Project No.0751
MHI Ref: UAP-HF-08037

Subject: Responses to NRC's Questions for NRC's Acceptance Review of the US-APWR
Design Certification Application

**MHI's Responses to NRC's Questions
for NRC's Acceptance Review
of the US-APWR Design Certification Application**

**MHI's Responses to NRC's Questions
on Design of the Sump Strainers**

Figure-1 ^{155}Gd and ^{157}Gd isotopic depletion

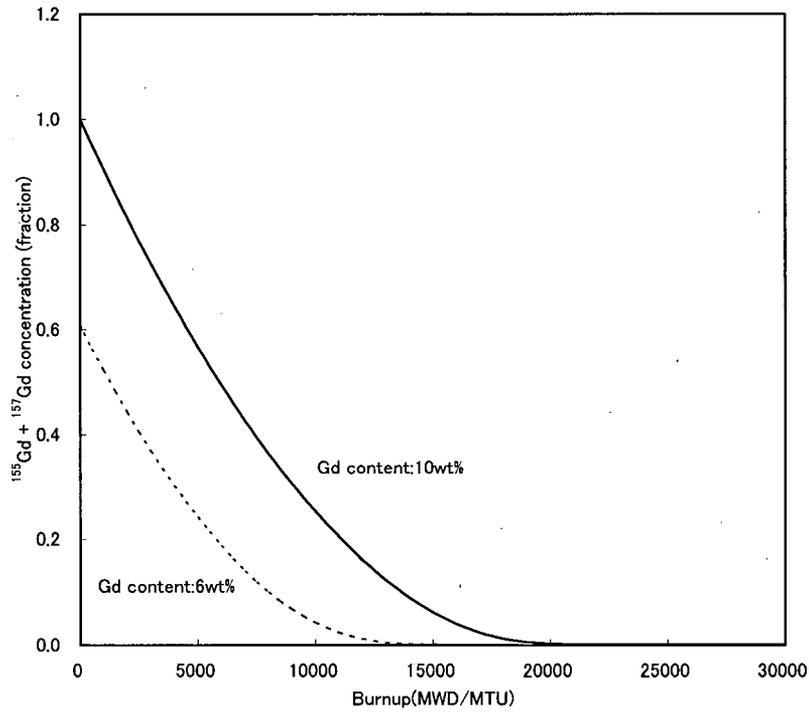
US-APWR DCD Section 4.3: The NRC requests MHI to provide a graphical or tabular depiction of Gadolinia depletion as a function of burnup.

Among Gd isotopes, ^{155}Gd and ^{157}Gd have the largest absorption cross sections and are therefore of primary interest. The depletion of these isotopes as a function of fuel burnup is described below for 4.15wt% fuel assemblies with 6wt% and 10wt% Gadolinia fuel rods, which belong to regions R3GC and R3GB of the US-APWR initial core shown in Figure 4.3-2 of the US-APWR DCD. The burnups of these fuel regions are shown in Table-1 for BOC, MOC and EOC.

Figure-1 shows ^{155}Gd and ^{157}Gd isotopic depletion, where the sum of initial number density of ^{155}Gd and ^{157}Gd of 10wt% Gadolinia fuel is normalized as a unit. ^{155}Gd and ^{157}Gd concentration decrease monotonically with increase of the burnup.
